Enclosed is PID No. 03-S-22 Revision I. This PID, which covers the drain installation, has been changed from a Class I to a Class II change and is for your information.

UMTRA PROJECT OFFICE
PROJECT INTERFACE DOCUMENT

Site Durango, CO	Date 12/20/89	PID No. 03-S-22, Rev 1	Site No. 3	Vic Pro No.
Originator and Location T. P. Jennings APO	Phone (505) 766-1667	Organization MK-F	Answer By:	References: Subcontract: Subcontract No:
Subject Toe Drain to be Installed on East Slope of Disposal Embankment

SKETCH TD-1

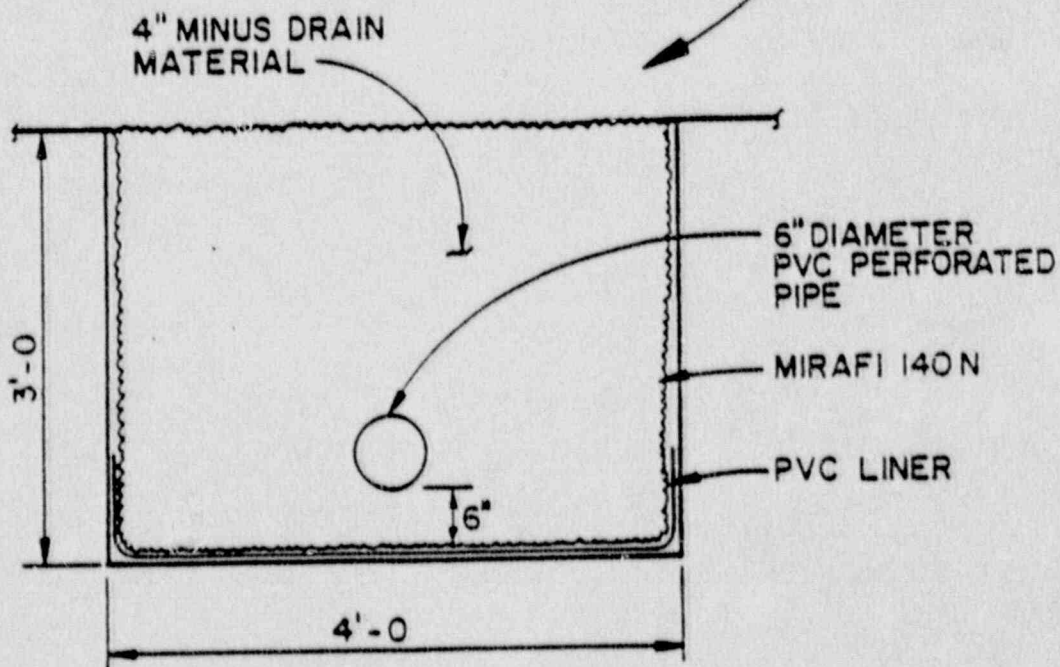
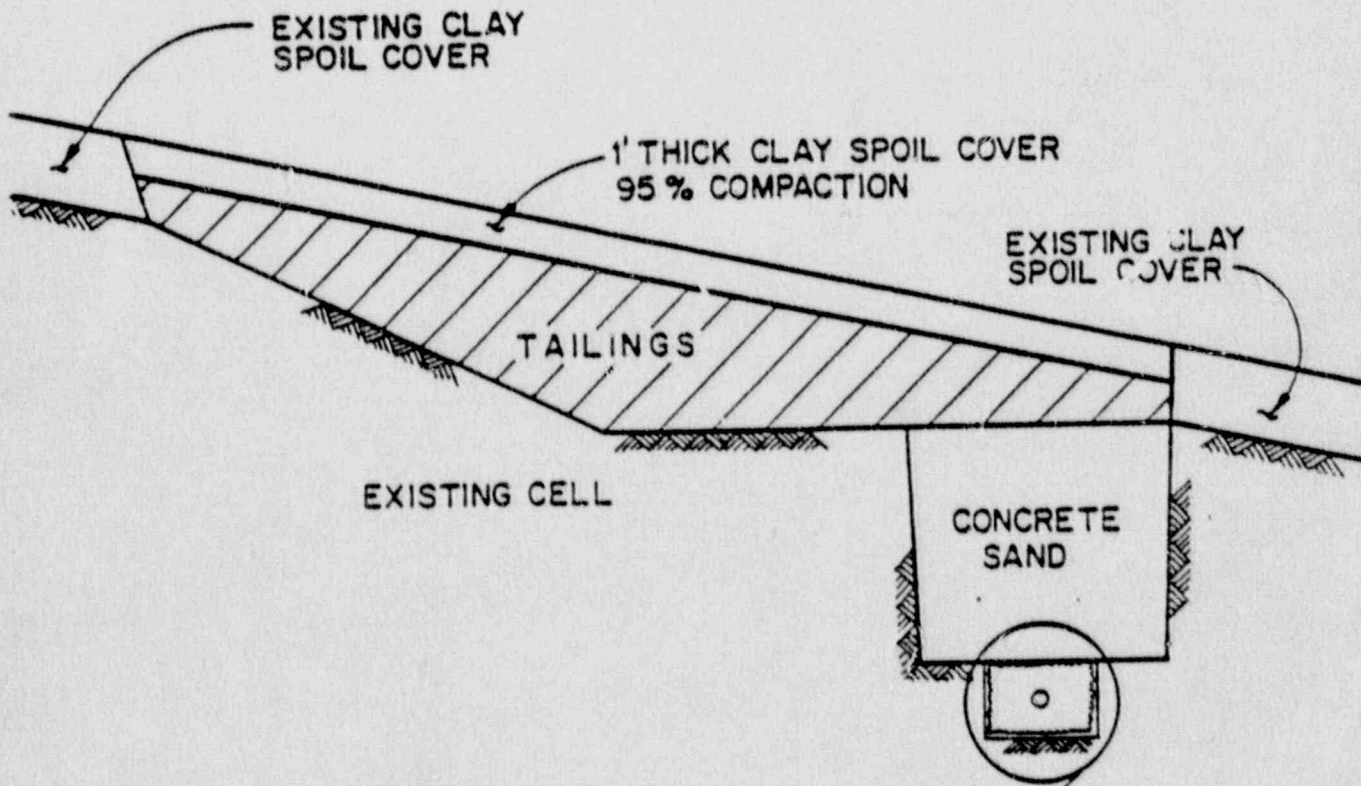
PROBLEM: The toe drain and holding pond were not constructed exactly as shown in Figures 1-3 to PID #03-S-22. These figures will be made into Subcontract Drawings. Since the toe drain is to be left in place, its as-built configuration has a bearing upon final NRC approval of the Disposal Cell. Therefore, the Subcontract Drawings which show the trench must be drawn to reflect the as-built condition and submitted for approval. In addition, various details should be included to reflect the as-built configuration.

1. Prepare the Subcontract Drawings to show the as-built toe trench configuration per the attached sketch TD-1.
2. Prepare the Drawings to show the rotation of the holding pond per the attached sketch TD-2, and PVC liner details per TD-3.
3. Revise Specifications provision 02142-2.1.A: Change "riprap. It shall be . . . 3-1/2-inch diameter" to "riprap, except that it shall be graded from a maximum size of 4-inch diameter".
4. All other Drawings and Specifications shall be per PID #03-S-22, Rev. 0.
